**APPENDIX B****Internal reports**

*Internal Report: Traffic Regulation and Safety***Bessboro – The Farm and Bessboro – The Meadows SHDs - Traffic Regulation & Safety Report**

Project:	Bessboro North “The Farm” Site SHD – Application
----------	--

Document:	Drainage Section Report & Conditions
-----------	--------------------------------------

Figure 1: Existing Site Location Plan (extract from Applicant drawing SB-2020-107-002)

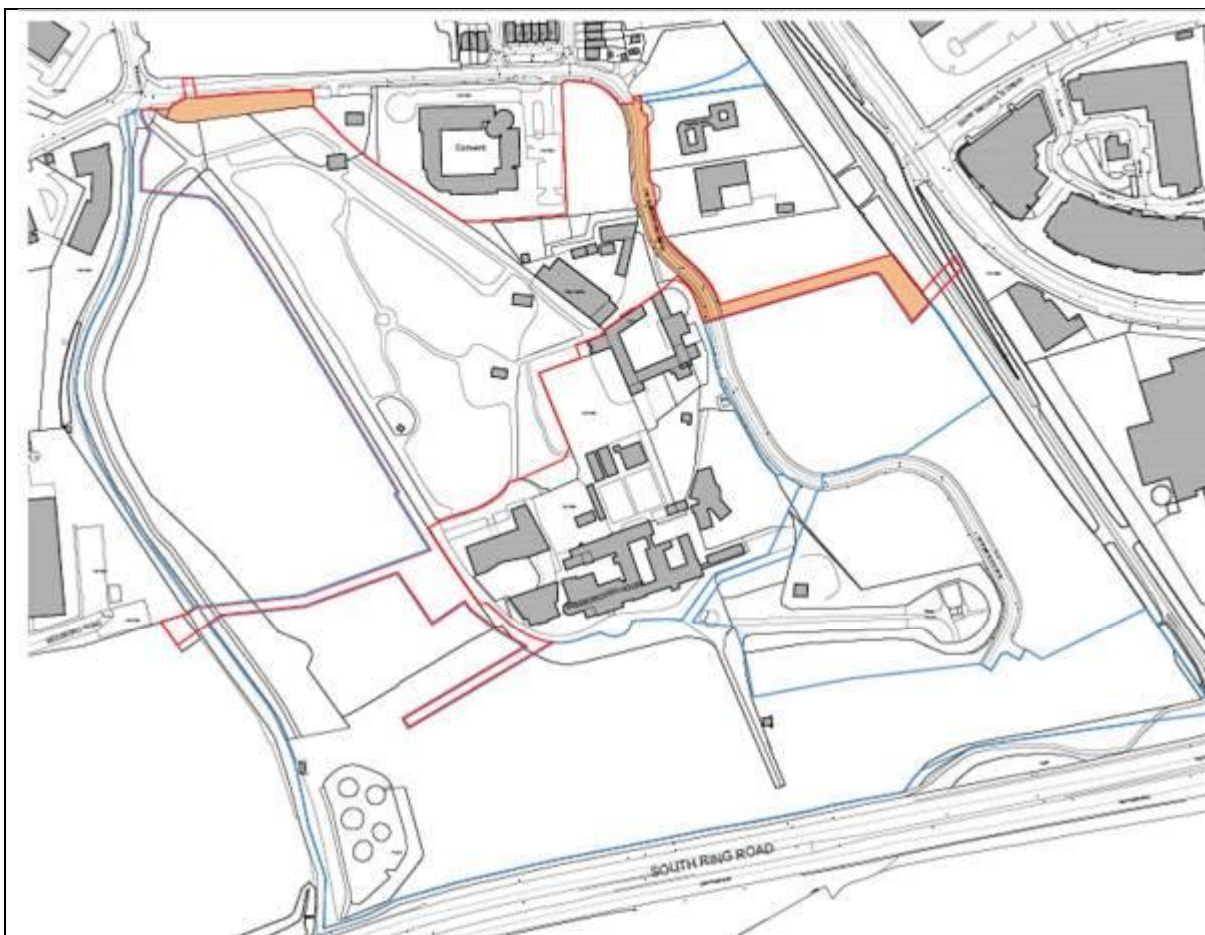
The South Ring Road (N40) is located approximately 250m from the southern boundary of the proposed development. The boundaries of the site are formed by the buildings, outbuildings, roads and open spaces of the overall Bessborough complex. The site slopes gently from north to south, with ground levels falling from approximately 18.00 m OD in the north-east of the site to 10.50 m OD in the south-west of the site
